SUBJECT: Revisions to Final Phase II RCRA Facility Investigation Work Plan, SWMU-11 Radiological Survey, March 2005

DUGWAY PROVING GROUND DUGWAY, UTAH

FINAL
PHASE II RCRA FACILITY
WORK PLAN

SWMU-11
RADIOLOGICAL SURVEY

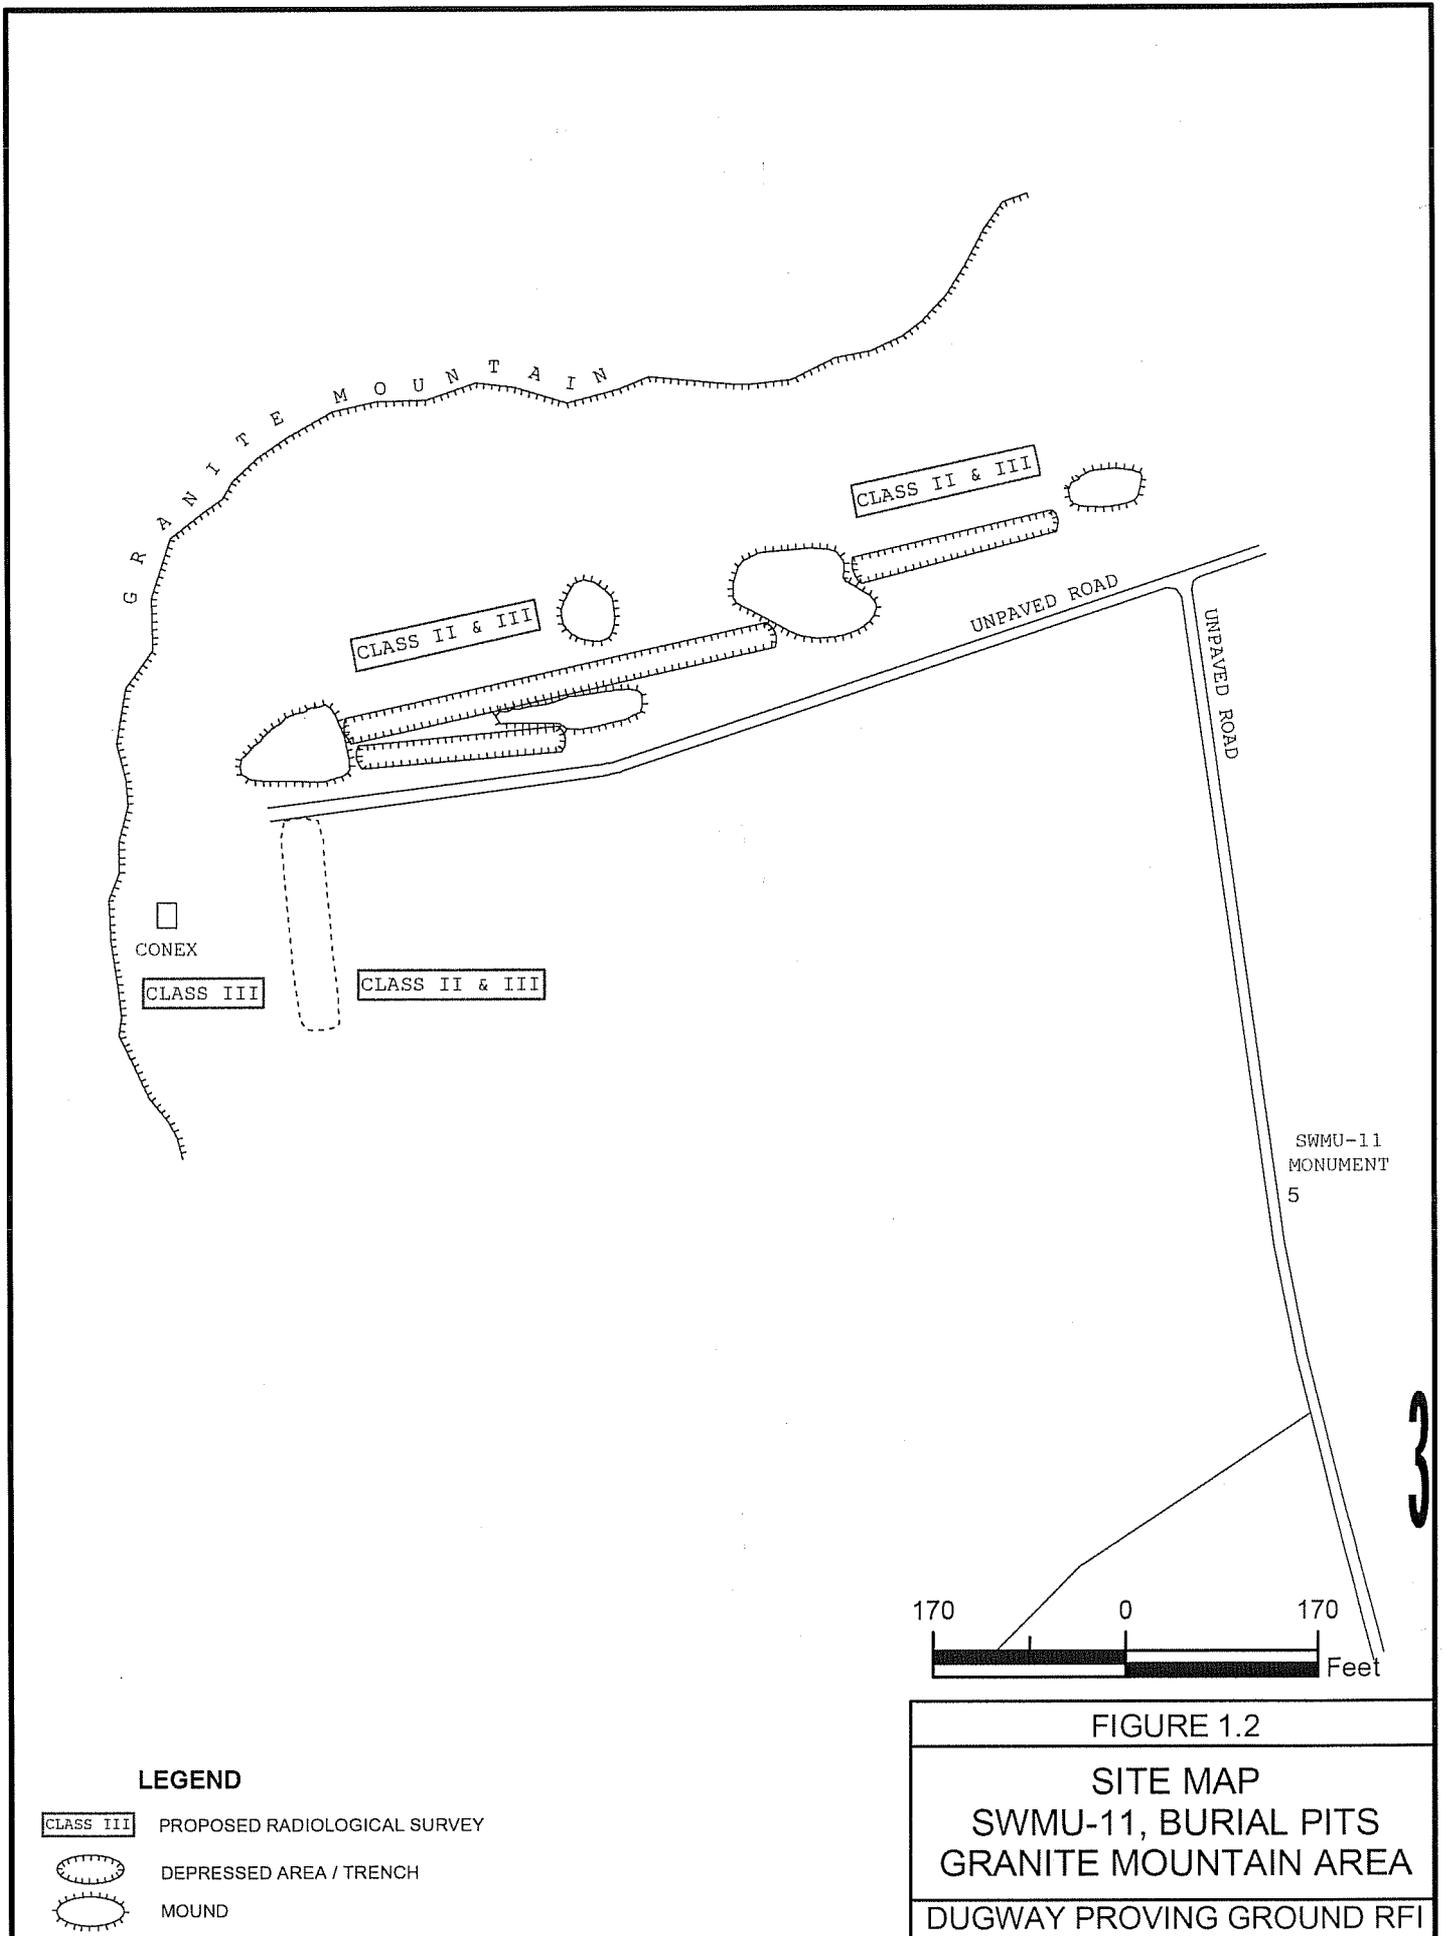
Page 3-6/Figure 1.2: SWMU-11 Survey Area: As described in the SWMU-11 characterization report, the survey area was increased as a result of the detection of a metal/radiological anomaly located to the south of the open trenches. Additional survey grids were established to the south and west of the open trenches.
